From: Oswald, Hank
Sent: Thursday, April 29, 2021 10:11 AM
To: Tony Fertitta (tonyf@fcc-eng.com); dcarter@bhbcmd.com
Subject: PC_12263 Blue Shy Evening Way_Floor Plan_Lot 6
Attachments: [Untitled].pdf

From: Oswald, Hank
Sent: Monday, May 3, 2021 8:44 AM
To: Donald Carter
Cc: Tony Fertitta (tonyf@fcc-eng.com)
Subject: RE: PC_12263 Blue Shy Evening Way_Floor Plan_Lot 6

**PERC RECERTIFICATION PLAT
FULTON WOODS
LOT 6
12263 BLUE SKY EVENING WAY
ZONED RR-DEO**

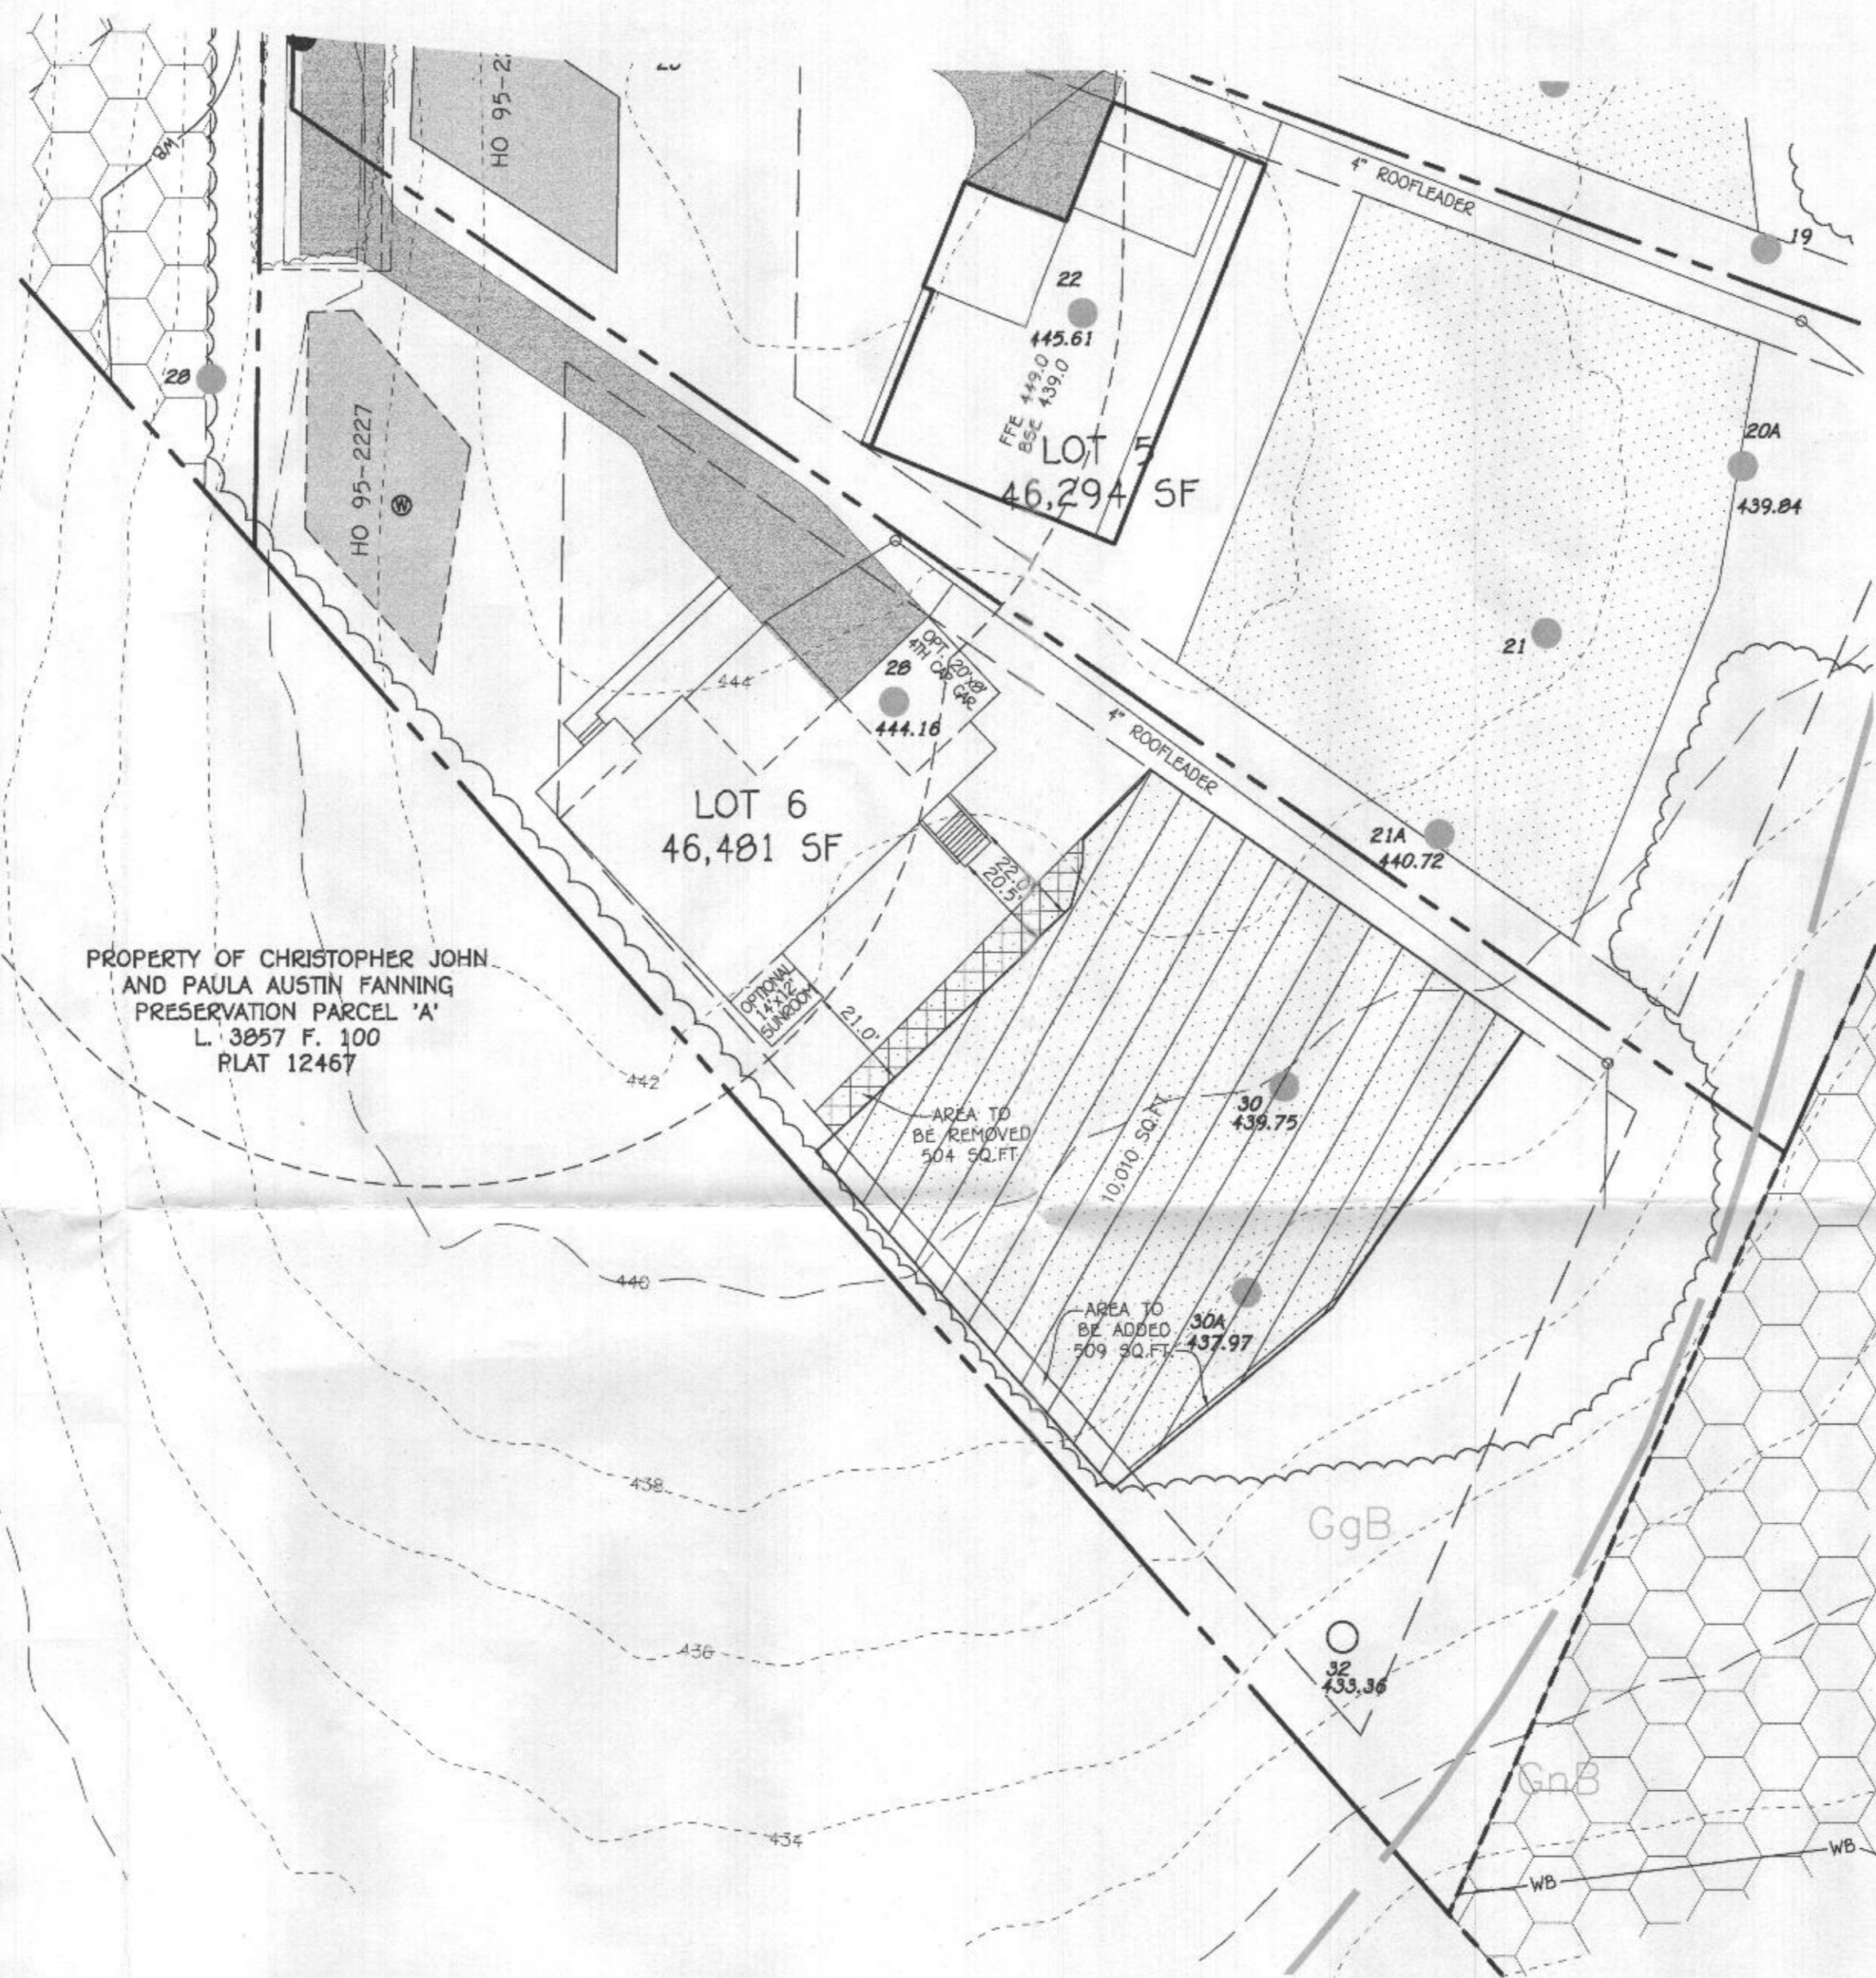
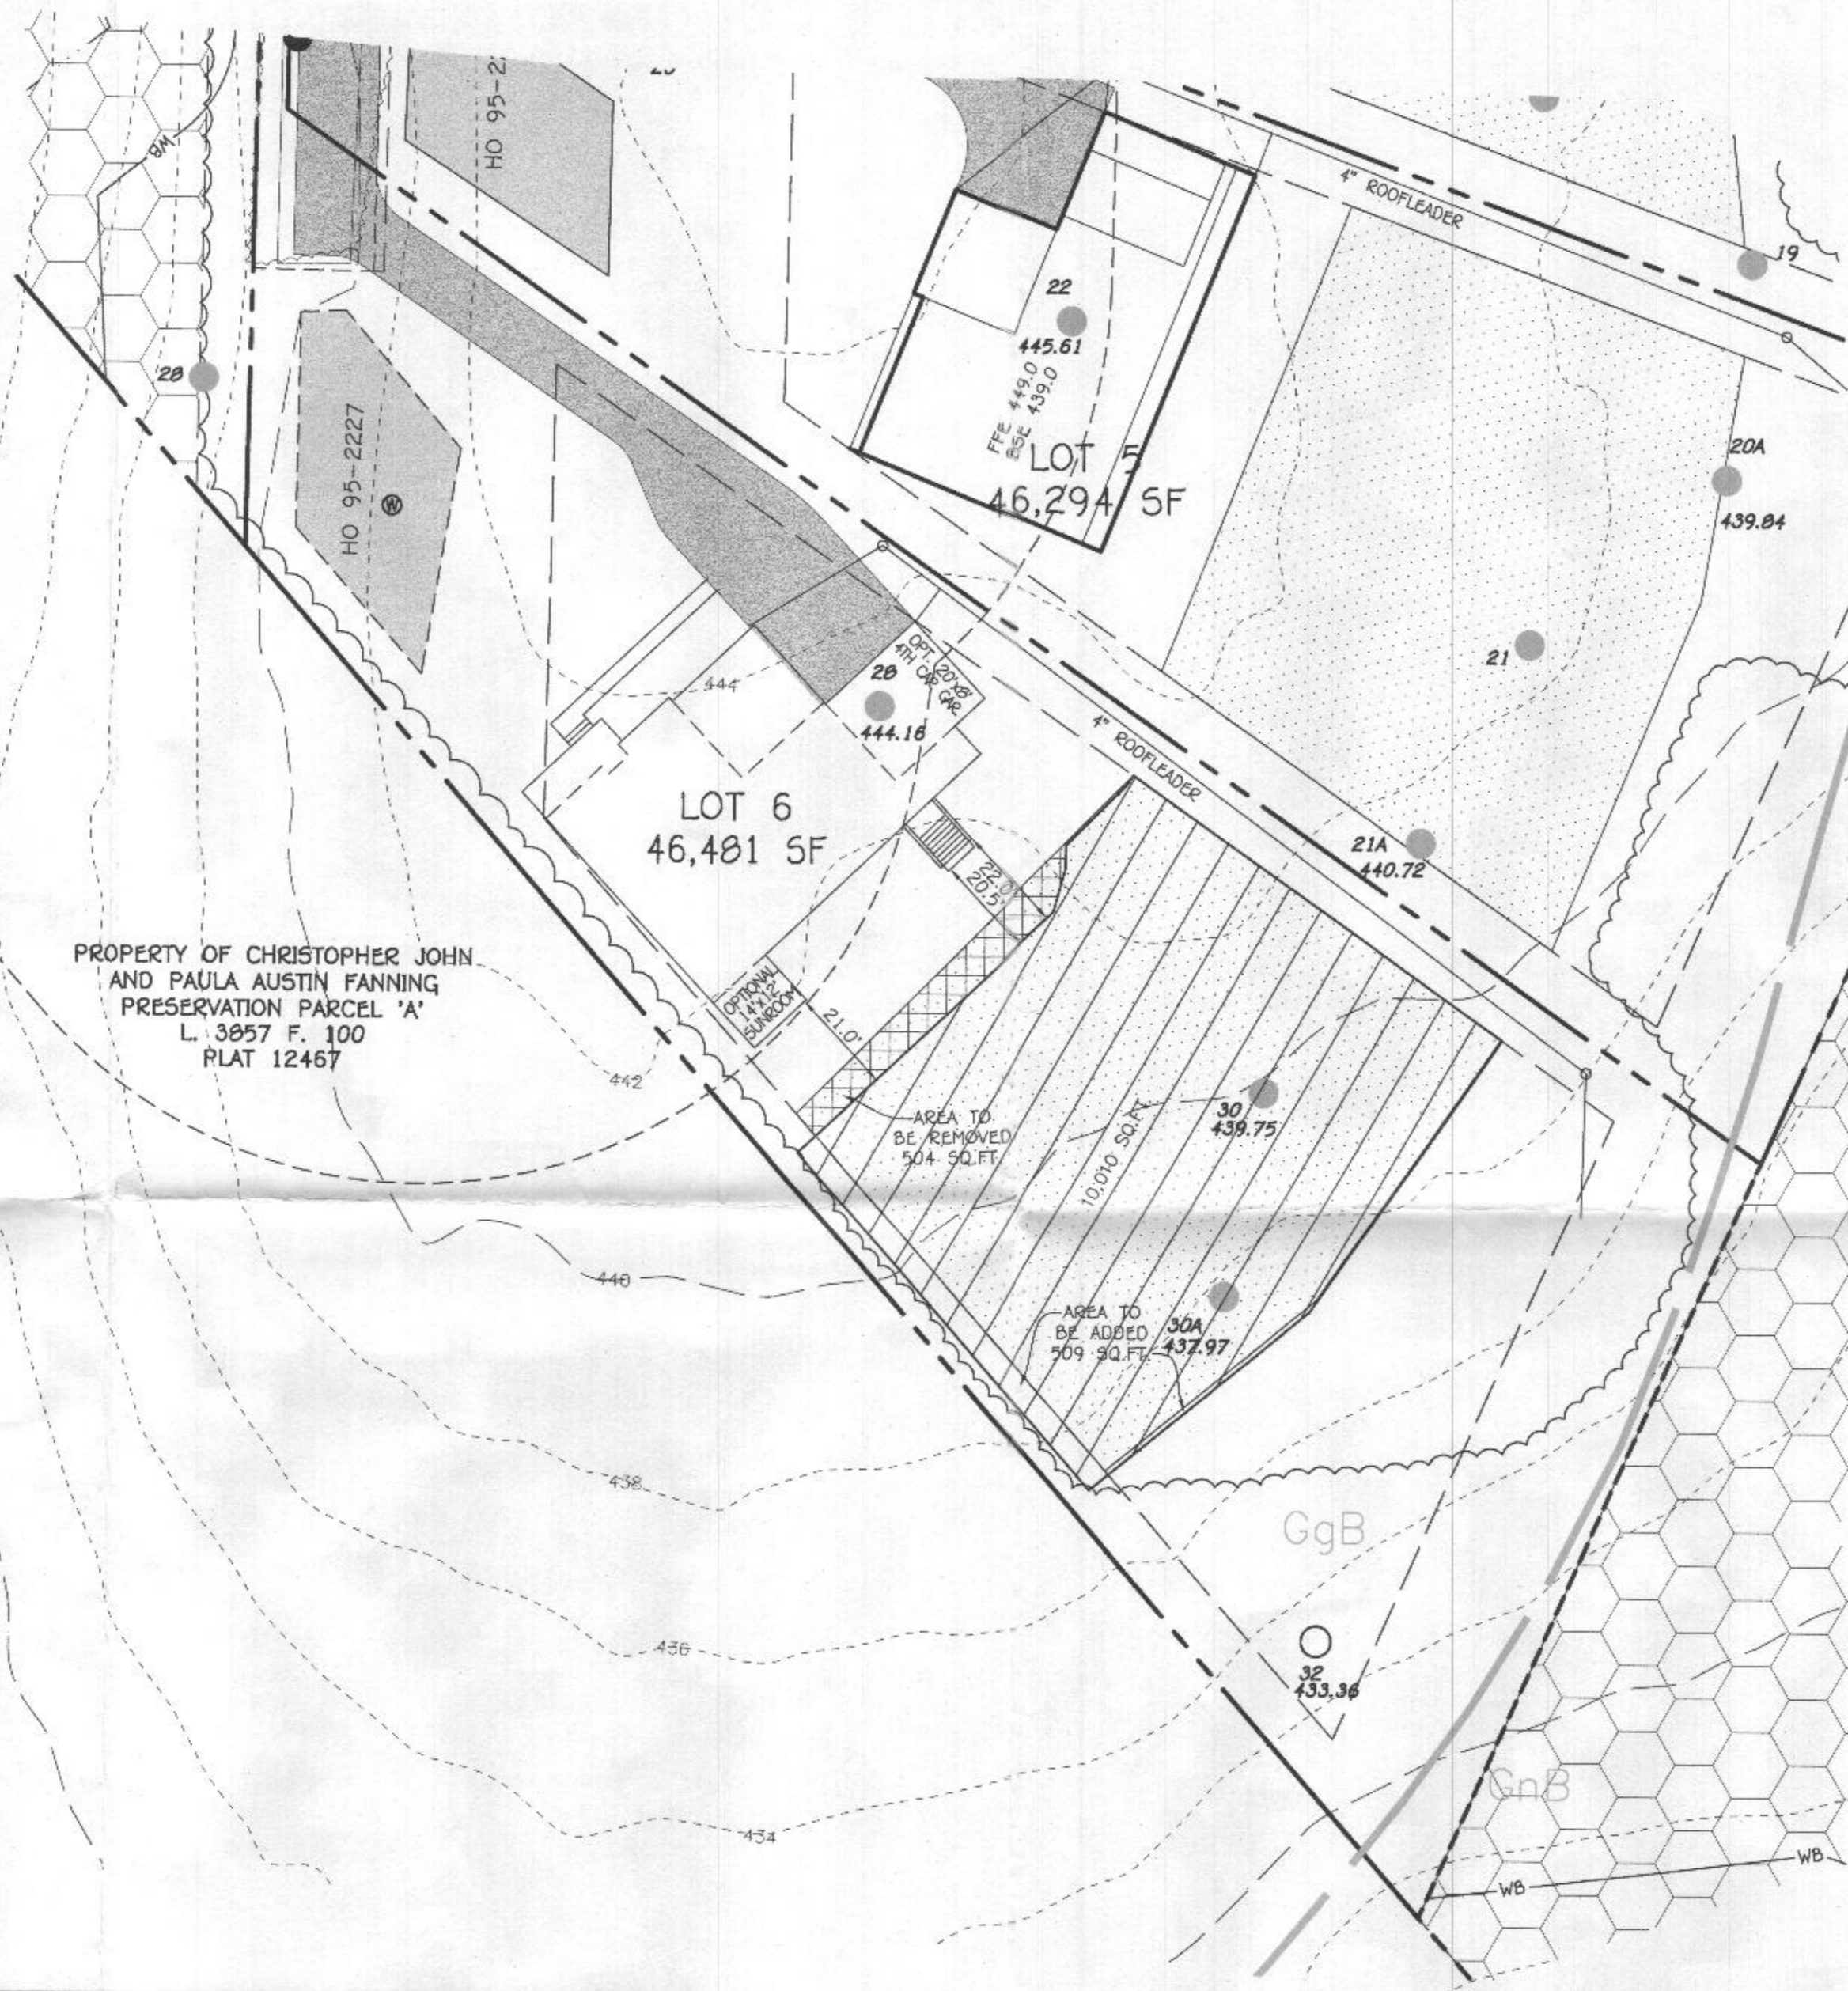
There was discussion back in March between Mr. Carter and my supervisor Jeff Williams. Please see attachments. We cannot approve the perc cert plan as shown.

The waiver request was approved. However, the PC plan needs a few minor revision.

- 1.) Add # to contour lines.
- 2.) Add total sq. ft. to SDA.
- 3.) Add elevation #'s next to each perc test hole.
